METROPOLITAN GOVERNMENT OF NASHVILLE AND DAVIDSON COUNTY

STAFF RECOMMENDATION 1701 A and C Blair Boulevard and 2117 and 2121 Belmont Boulevard March 18, 2015

Application: New construction-infill
District: Belmont-Hillsboro Neighborhood Conservation Zoning Overlay
Council District: 18
Map and Parcel Number: 10416040600, 10416040500, 10416040400, 10416040300
Applicant: Allard Ward Architects
Project Lead: robin.zeigler@nashville.gov

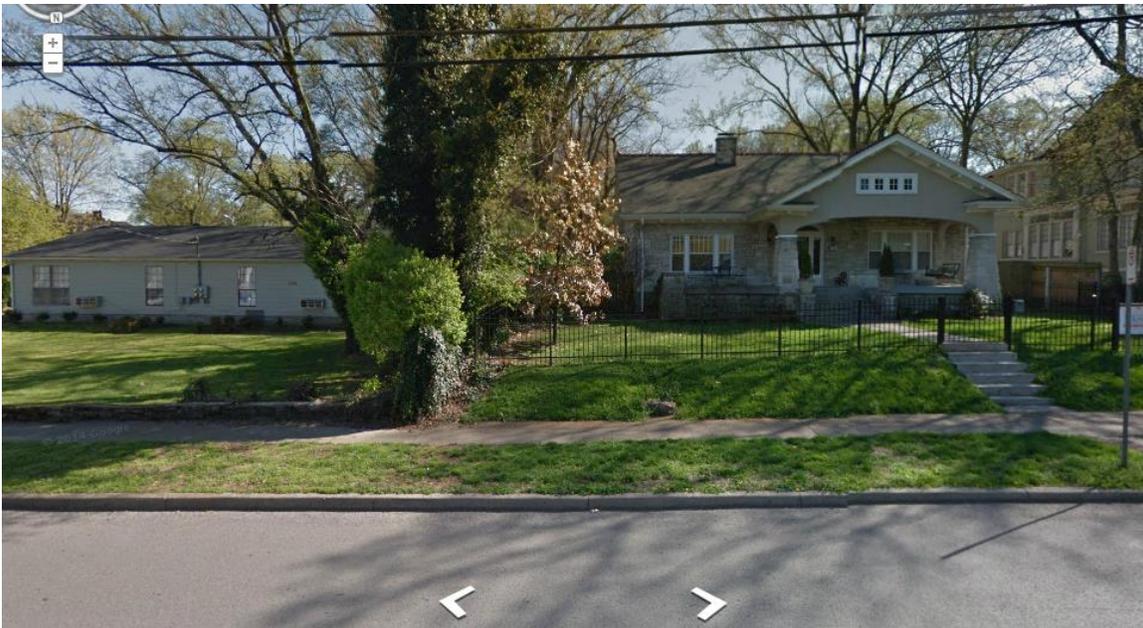
Staff recommends approval with the conditions that:

- A walkway be added to connect the rear units to the street;
- The finished floor height be consistent with the finished floor heights of the adjacent historic houses, to be verified by MHZC staff in the field; and,
- If the SP is approved by the Planning Commission, the applicant will return to the Commission with a second application for review of materials; windows and doors; proportion and rhythm of openings; balconies and awnings; appurtenances and utility locations; and the overall detailing of the proposal.
